Evaluation of proposed move for Water Right No. 43662

Proposed: Move water right no. 43662 to a new well location, 2,347 ft to the northwest. Water right numbers 41216 & 42827 will remain at the original location. This is an additional well.

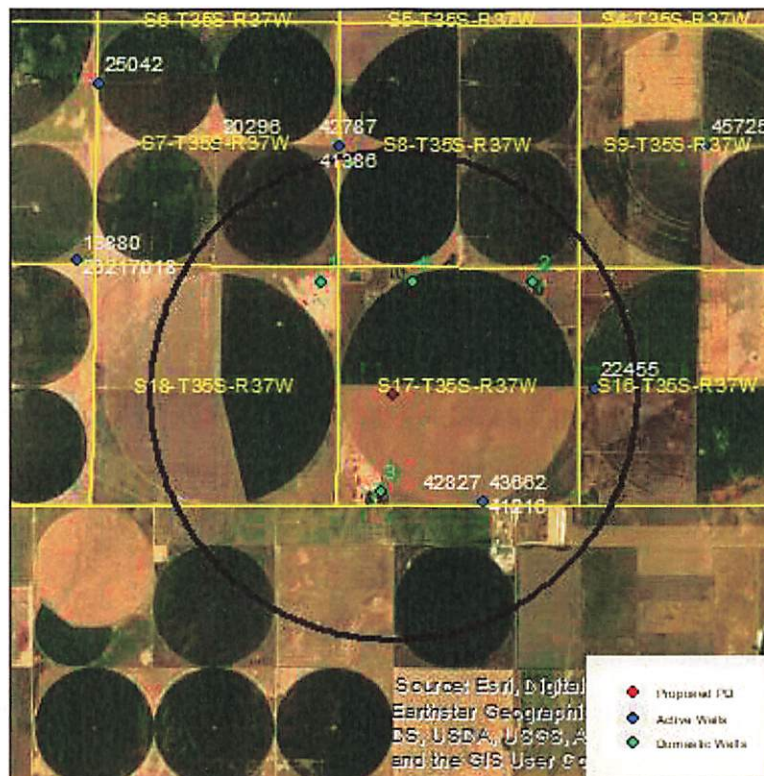
Wells within 1 mile: 41216 & 42827, 22455, and four domestic wells, numbered on the above map.

Net drawdown exceeds the drawdown allowance for all wells within 1 mile of the proposed location. Critical well analysis is necessary on those wells.

WELL TEST ANALYSIS

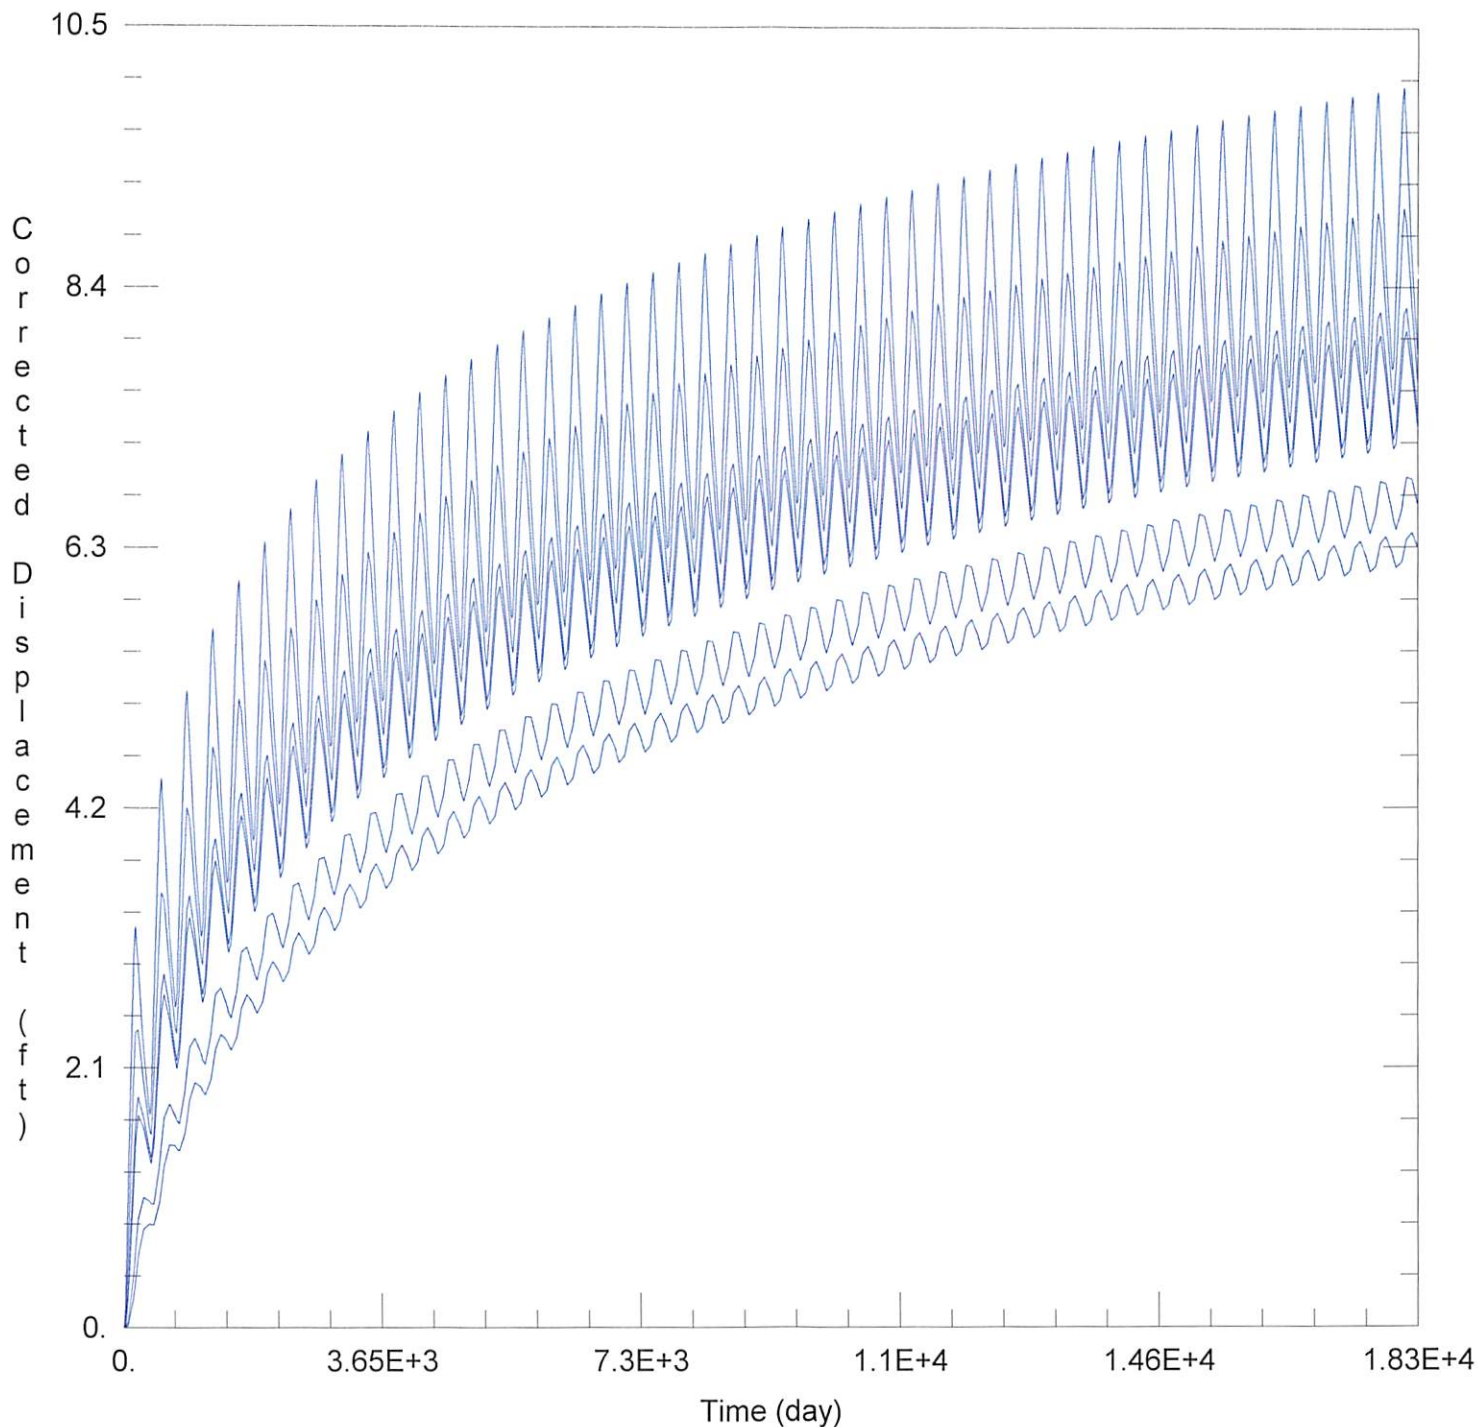
50 year Theis Analysis: The following values were used to run the analysis:

$S = 0.1395$, $T = 2469 \text{ ft}^2/\text{day}$, $t_{p\text{proposed}} = 145 \text{ days}$, $Q_{\text{proposed}} = 700 \text{ gpm}$

Theis drawdowns were calculated as follows:

41216 & 42827: Net drawdown = **8.0 ft**
